Form 3160-5 (February 2005)

UNITED STATES DEPARTMENT OF THE INTERIOR AUG 1 6 2010 BUREAU OF LAND MANAGEMENT

1. Type of Well Oil Well] Gas Well 🔀 Otl	ner SWD			
				8. Well Name and No. Rosa Unit SWD #2	
Name of Operator Williams Production Compa	9 API Well No. 30-039-30812				
3a Address PO Box 640 Aztec, NM 87410		3b. Phone No. <i>(include area code)</i> 505-634-4208		10. Field and Pool or Exploratory Area Entrada

DRILLING CONDITIONS OF APPROVAL

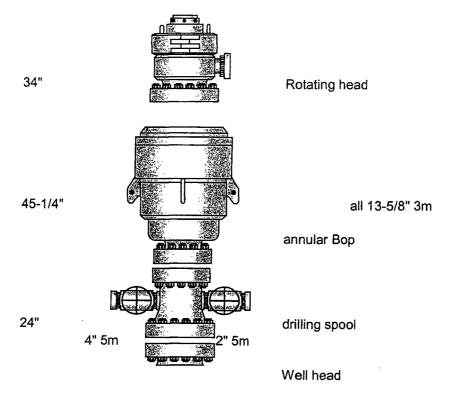
Williams Production requests authorization to change to use a 3000# annular BOP with drilling spool as per the attached schematic diagram in lieu of the double ram BOP system permitted. Due to the large diameter casing design on this well there are safety concerns in nippling up a double ram BOP stack under the small sub structure. We would request that this BOP system be used from spud thru TD of the well.

1) Since no BOPE test pressures were proposed, it is recommended that Williams Production test the BOP and related equipment according to Onshore Order No. 2 Minimum Standards and Enforcement Provisions For Well Control Equipment Testing.
